Product/Process Change Notice (PCN)

PCN #: ConUSB_20141001
Product Affected: 61400413321 / 61400414122
Effective Date: January 1ST, 2015

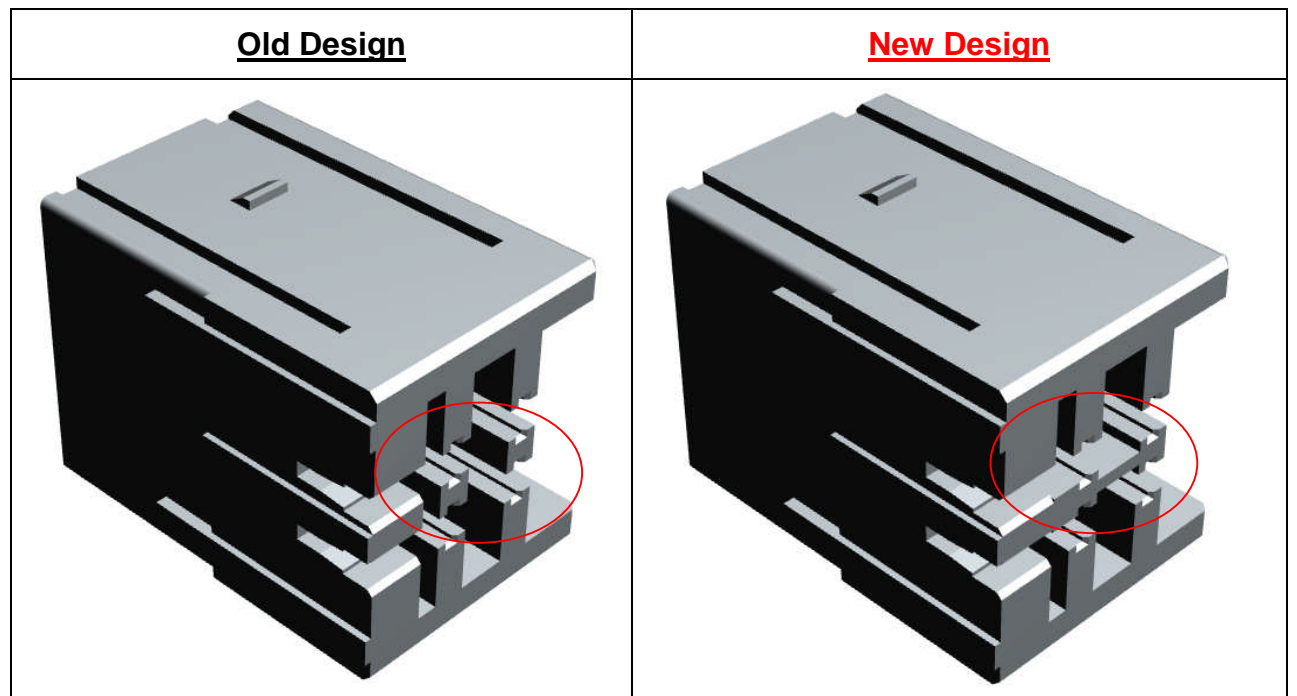
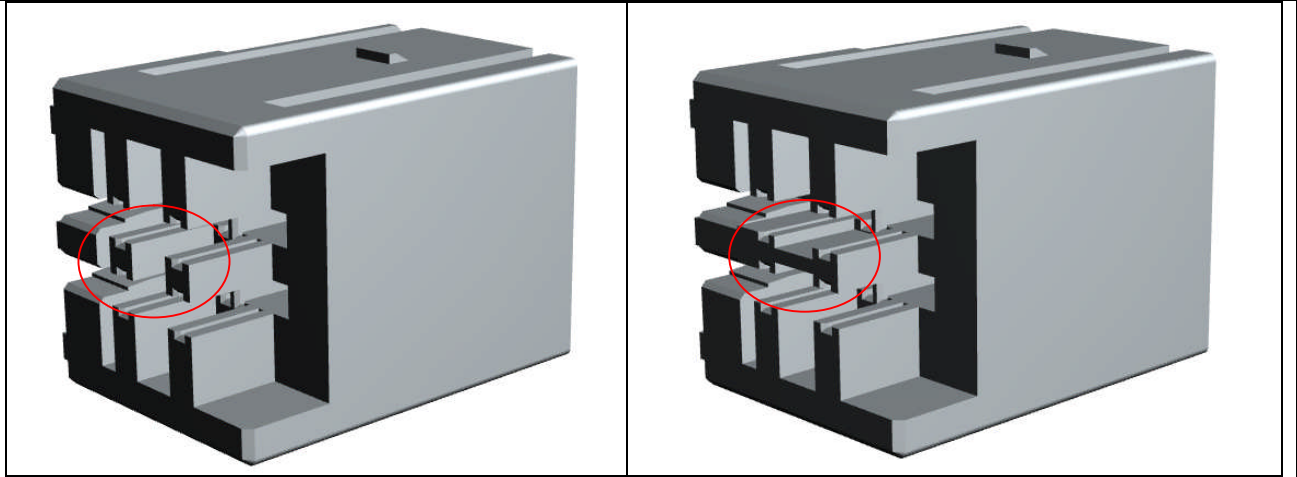
Würth Elektronik changed the product design to enhance the reliability.

The design of insulator will be changed to avoid the tin to go inside the connector during welding on the wave soldering machine. Nevertheless, all electrical and mechanical properties and dimensions remain for both part numbers (61400413321 – White version and 61400414122 - Black version).
